INTERNATIONAL BOUNDARY AND WATER COMMISSION		
UNITED STATES AND MEXICO		
UNITED STATES SECTION		
USIBWC REAL PROPERTY ASSESSMENT		
PROJECT: GO FUND ME FENCE		
EOF:	N/A	R/W FILE No. N/A
NEW MEXICO STATE PLANE CENTRAL		
UPDATE BY:	(b) (6)	JUNE 4, 2019

**Review:**

**EXHIBIT A – Map of Mexican Encroachment. Protective Works Above AD CAD New Mexico Central 9.21**  
**EXHIBIT B – Mexican IBWC photographs showing boundary lines.**  
**EXHIBIT C – Attachment “We Build The Wall; initial Project at AEB**

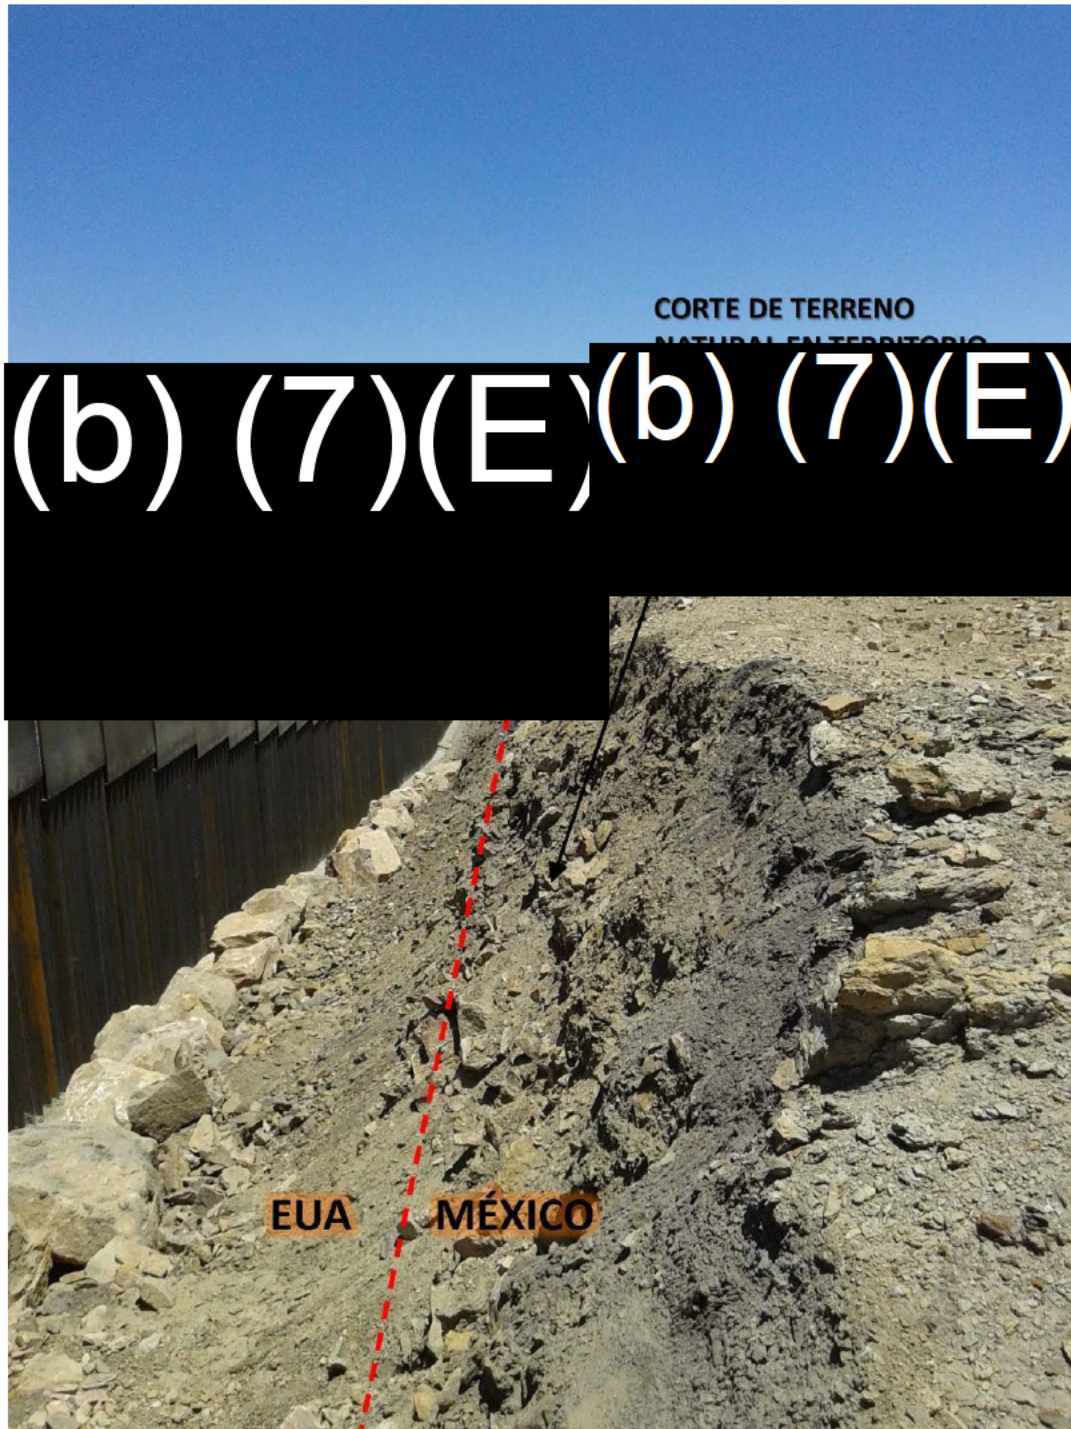
- F. As per the attached photo Titled "EXHIBIT A", areas have been identified by CILA where construction fill has spilled over into Mexico. These areas can be identified as mounds in the soil profile. Please remove the fill.*

5. As per the attached photo, areas have been identified by Mexican IBWC (GILA) where construction fill has spilled over into Mexico. These areas can be identified as mounds in the soil profile. Please remove the fill.

- *Fisher Industries response: The photo does not accurately depict the international boundary or the placement of fill. The construction equipment and personnel were very careful to never enter into Mexico. If some minor amount of the rocky material rolled off the slope it is not meant as an intentional affront to our neighbor or as any form of trespass. Due to the terrain and past activities the materials in this area have been comingled in the past due to both natural and mechanical processes.*
- *USIBWC response: The USIBWC has verified the location of the international boundary. Contractor must remove all fill that encroached into Mexico. Please see "EXHIBIT A"*
